Delegated Report

Application No: 20230743

Location: Site Of Former Police Station, 133 Windmill Street, Gravesend

Description: Application for the approval of condition 18 and 21 attached to planning permission 20220432 relating to details of the installation of fixed telecommunication infrastructure and High- Speed Fibre Optic (minimal internal speed of 1000mbps) connections to multi point destinations and all buildings and full details of the cycle storage facilities.

Crosskirk Cycle Stand

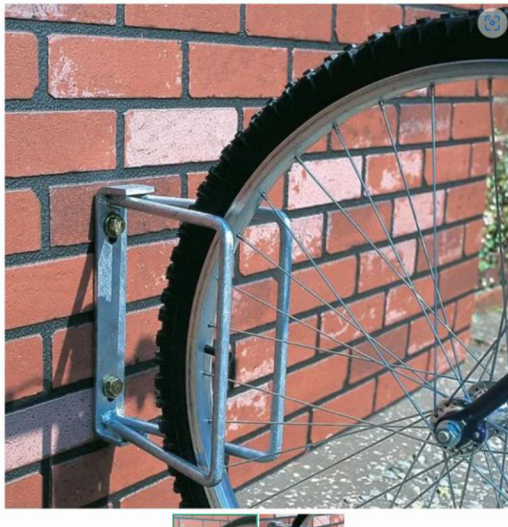
There is no adopted guidance or policy that I'm aware of that restricts the type of cycle stand, although my understanding is full frame stands are preferred as this minimises the risk of damage particularly to the wheels, which can occur with the type of stand proposed.

Looking at the supplier's web site I note that they state the stands are suitable for short term parking, which is not the case here.

Also, the proposal does not appear to be particularly well suited for adaptive cycles as there may be the need to accommodate tricycles or similar cycles given the intended residents of the site.

Please note LTN1/20 Local Transport Note 1/20 published by the Department for Transport, gives the typical width of a cycle as 0.65m so 6 cycles require 3.9 metres without any gaps between them and no provision for tricycles. With an internal width of less than 4.5 metres, this gives less than 86 mm between parked cycles or cycle and the wall, which could be a limiting factor when guiding a cycle into or out of the rack. The suggested spacing between Sheffield Stands is a minimum of 1 metre with 1.2 metres preferred.

My suggestion is the proposal should be refused as it does not permit the parking of adaptive cycles and so is not inclusive and could deter Active Travel by the less able of the residents.

The applicant has submitted a drawing in support of discharging this condition. The drawing shows the cycle store to the rear/central part of the building. It will not be readily visible from the surrounding street scene and conservation area. Although the bike stands are not ideal and are more suited to short term use, the site will be accessed by a security gate which will offer additional security. The area is approx. 4m x 5.5m which does provide some limited space between cycles. This is not ideal but, on balance, space for six cycles as required by the condition is provided. This is acceptable and this condition can be discharged.
